ADDENDUM NO. 3

SCALE AS NOTED		DESIGNER: A. MARGIOTTA	STATE OF CONNECTICUT DEPARTMENT OF TRANSPORTATION	PROJECT TITLE: CHURCH STREET SOUTH EXTENSION OVER NEW HAVEN INTERLOCKING AND RAIL YARD	TOWN: NEW HAVEN	PROJECT NO.: 92-526
		DRAFTER: M. OFFENBERG		ENGINEER: PARSONS BRINCKERHOFF QUADE & DOUGLAS, INC.	DRAWING TITLE: MISCELLANEOUS DRAINAGE DETAILS	DRAWING NO.:
		CHECKED BY: A. MORETTI		CADD FILE: AD3R703D013.MDS		SHEET NO.: 23
		DATE CHECKED: 4-9-00		PLOTTED DATE: 11-22-00

DESIGNER: D. GEISSERT DRAFTER: D. GEISSERT CHECKED BY: A. MORETTI DATE CHECKED: 4-8-00		 STATE OF CONNECTICUT DEPARTMENT OF TRANSPORTATION		PROJECT TITLE: CHURCH STREET SOUTH EXTENSION OVER NEW HAVEN INTERLOCKING AND RAIL YARD		TOWN: NEW HAVEN		PROJECT NO.: 92-526	
ENGINEER: PARSONS BRINCKERHOFF QUADE & DOUGLAS, INC. APPROVED BY: <i>Anthony A. Morretti</i>		DATE: 11/28/00		DRAWING TITLE: GENERAL NOTES		DRAWING NO.: STR-4		SHEET NO.: 138	
CADD FILE: AD3R703S003.DGN		PLOTTED DATE: 11-27-00

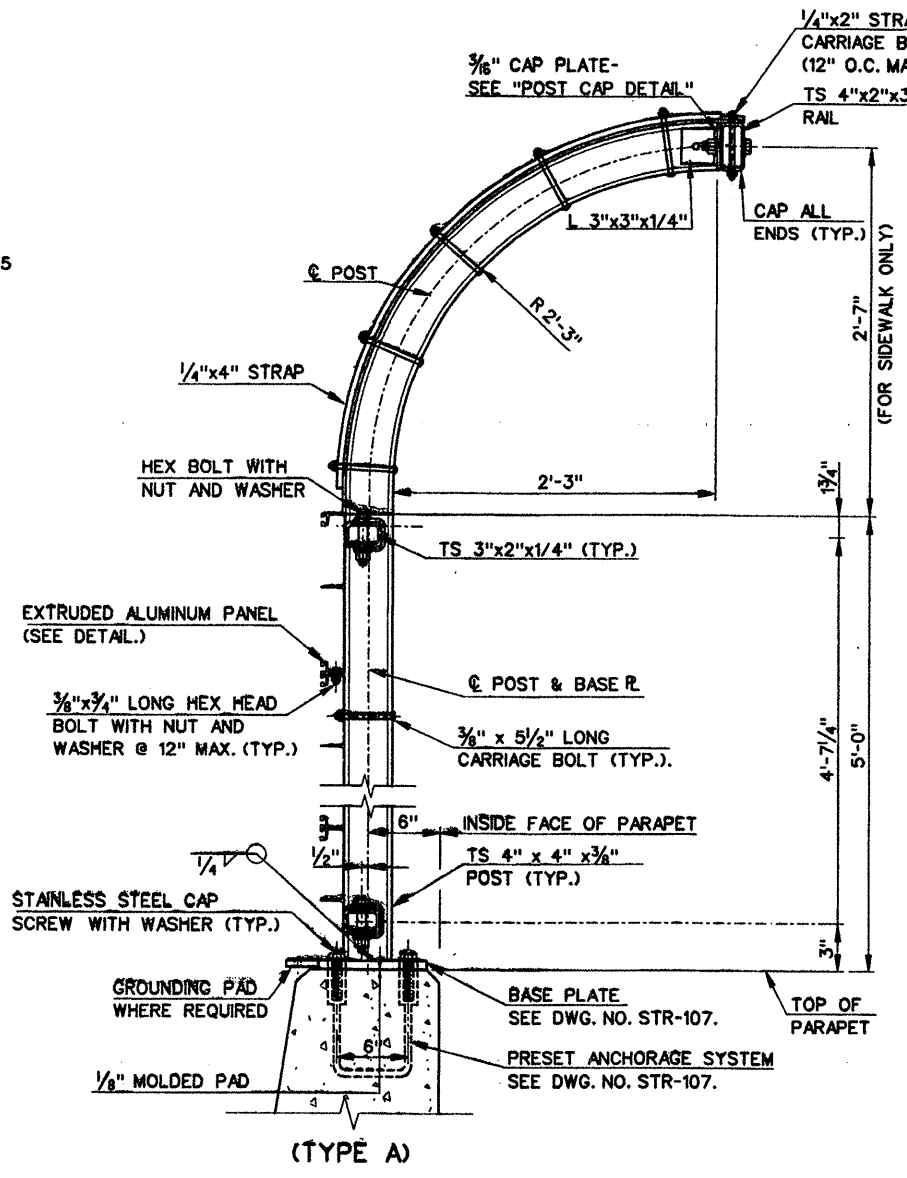
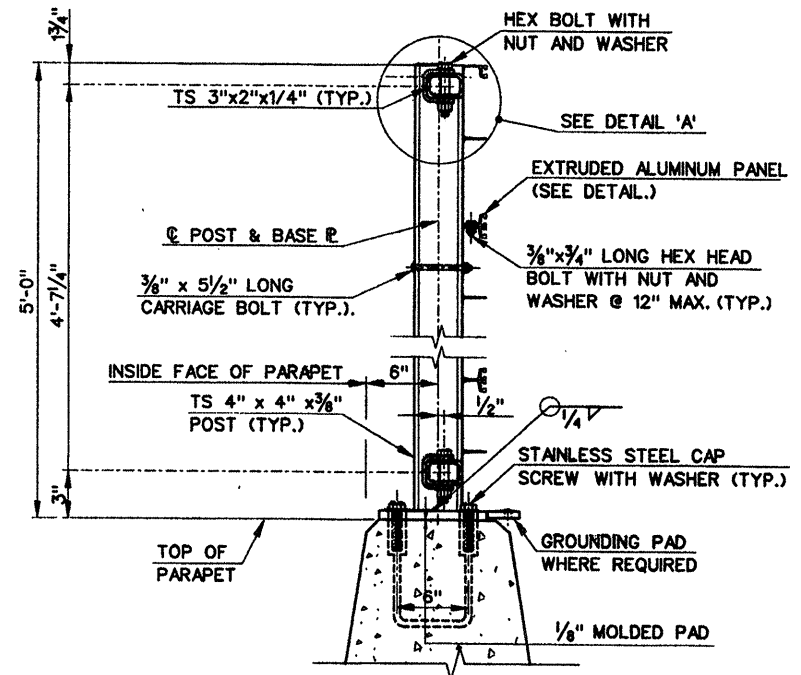
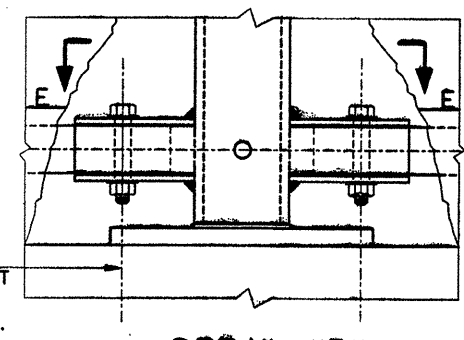
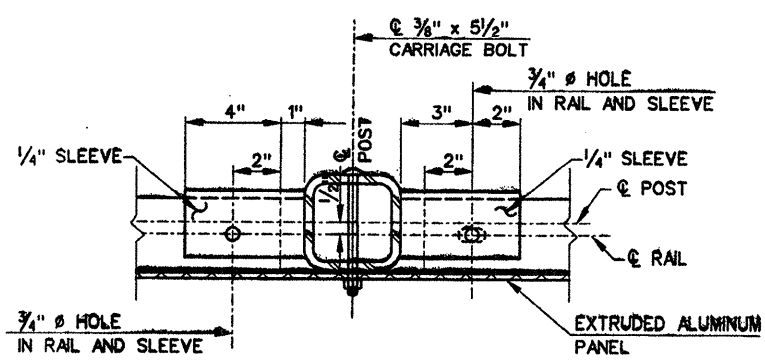
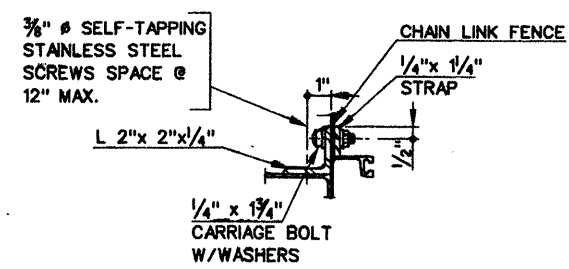
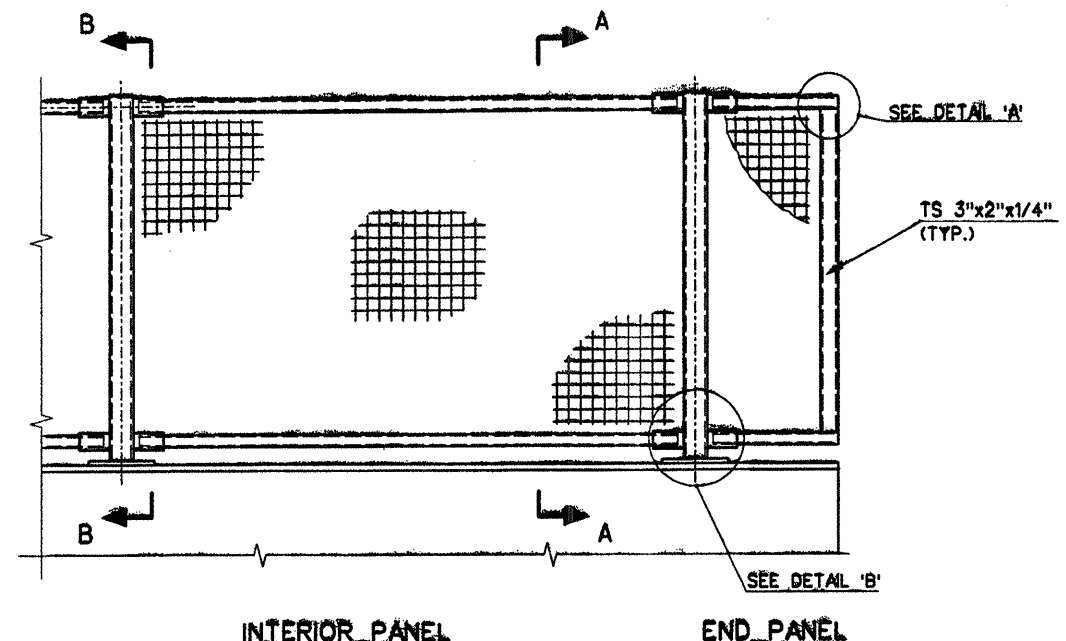
2. ALL CAP SCREWS SHALL BE STAINLESS STEEL AND CONFORM TO THE REQUIREMENTS OF ASTM A193, CLASS 1 OR 2, GRADE B8M (ASITYPE 316). STAINLESS STEEL WASHERS SHALL CONFORM TO ASTM A240, TYPES 302-305.

DRAWING TITLE:  
**METAL BRIDGE RAIL PROTECTIVE  
 FENCE (TYPE C)- SHEET 1 OF 2**

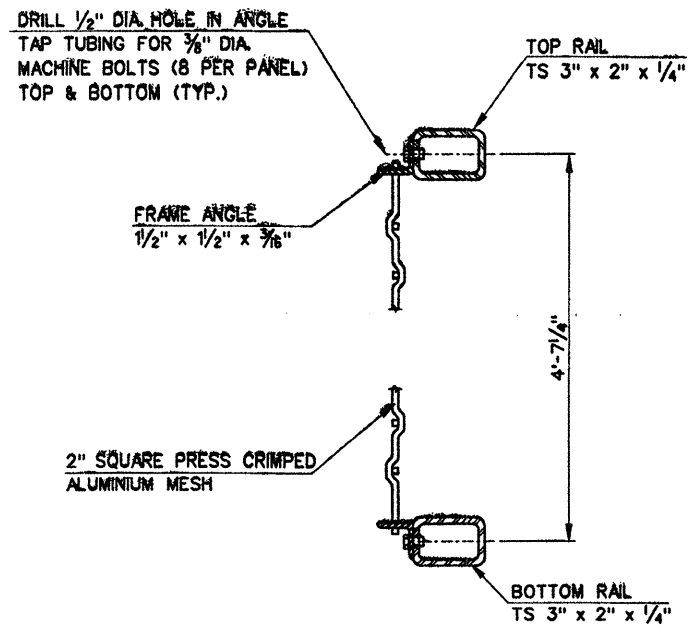
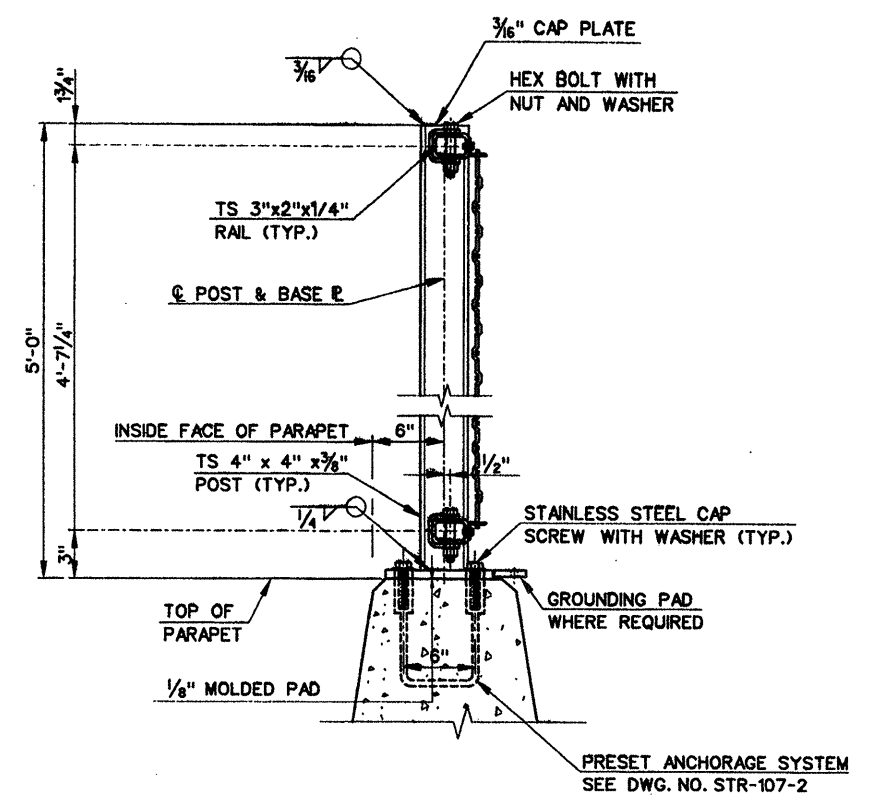
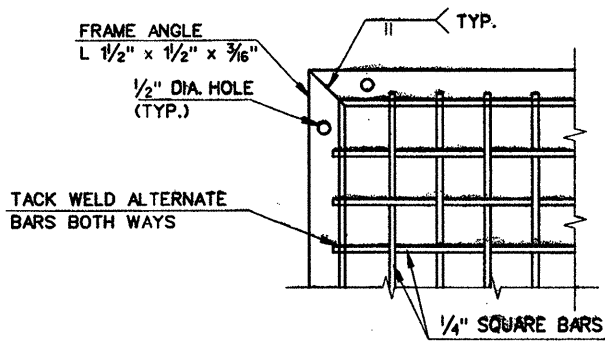
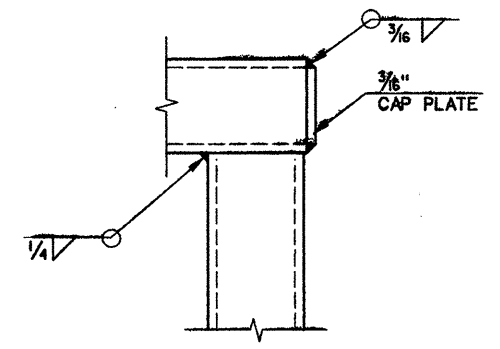
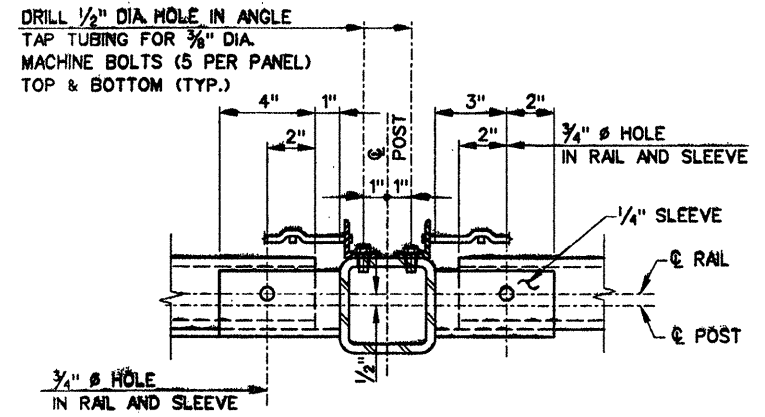
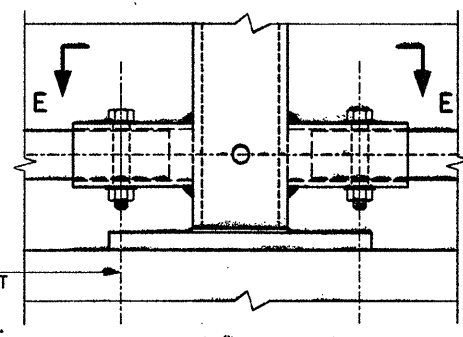
REV.	DATE	DESCRIPTION	SHEET NO.
11-22-2000		ADDENDUM NO. 3 - BOLT MATERIAL	241-1
11-7-2000		ADDENDUM NO. 2 - BRIDGE RAIL COLOR CHANGED	241-1
		REVISIONS

1. THE POSTS, RAILS, BASES, SLEEVES AND CONNECTION MATERIAL SHALL BE EXTRUDED ALUMINUM CONFORMING TO ASTM B221, ALUMINUM ALLOY 6061-T6 AND SHALL BE ANODIZED (CLEAR) SEE SPECIAL PROVISION.
2. ALL CAP SCREWS SHALL BE STAINLESS STEEL AND CONFORM TO THE REQUIREMENTS OF ASTM A193, CLASS 1 OR 2, GRADE B8M (AISI TYPE 316). STAINLESS STEEL WASHERS SHALL CONFORM TO ASTM A240, TYPES 302-305.
3. FOR RAIL POST SPACING SEE SLAB PLANS.
4. THE RAILING SHALL BE FABRICATED AND ERECTED SO THAT THE RAILS ARE PARALLEL TO EACH OTHER AND TO THE PARAPET AND THE RAILING POSTS ARE VERTICAL.
5. EXPOSED SURFACES OF POSTS, RAILING, CONNECTION SLEEVES, ANGLES AND RAILING PANELS SHALL BE FREE OF BURRS, IRREGULARITIES AND SHARP EDGES.
6. FOR CONNECTION TO THE GROUNDING AND BONDING SYSTEM, SEE DWG. NO. STR-118. GROUNDING PADS ARE TO BE PAID FOR UNDER THE ITEM METAL BRIDGE RAIL-PROTECTIVE FENCE (TYPE C).

TOWN: NEW HAVEN  
 DRAWING TITLE: METAL BRIDGE RAIL  
 (COMBINATION) (EXTRUDED ALUMINUM)

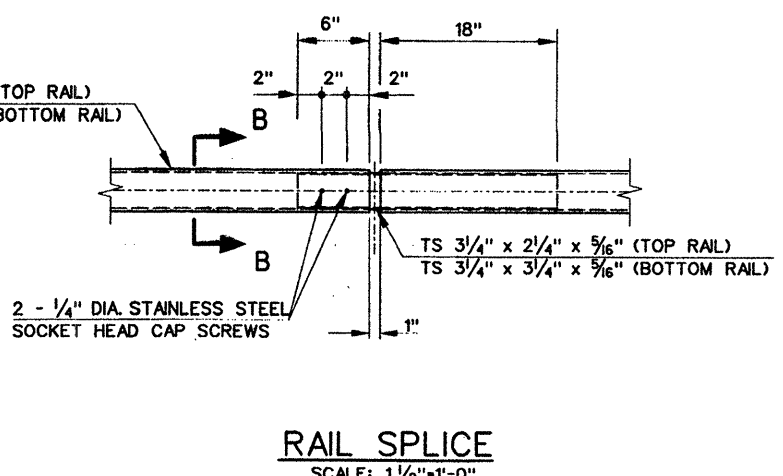
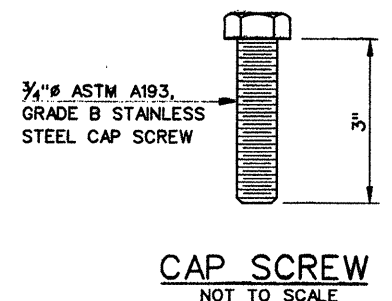
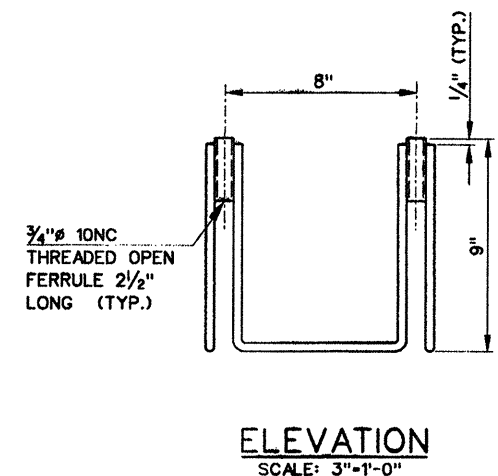
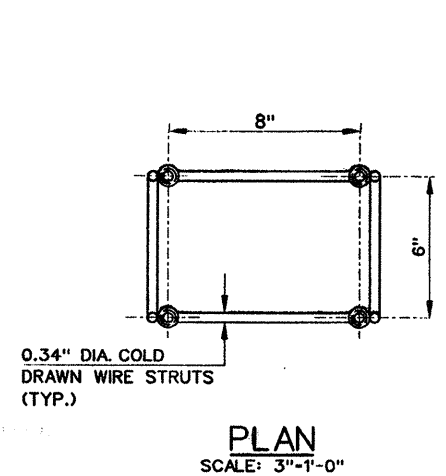
REV.	DATE	DESCRIPTION	SHEET NO.
1	11-21-2000	ADDENDUM NO. 3 - BOLT MATERIAL	243
2	11-7-2000	ADDENDUM NO. 2 - BRIDGE RAIL COLOR CHANGED	243

2. ALL CAP SCREWS SHALL BE STAINLESS STEEL AND CONFORM TO THE REQUIREMENTS OF ASTM A193, CLASS 1 OR 2, GRADE B8M (AISI TYPE 316). STAINLESS STEEL WASHERS SHALL CONFORM TO ASTM A240, TYPES 302-305.
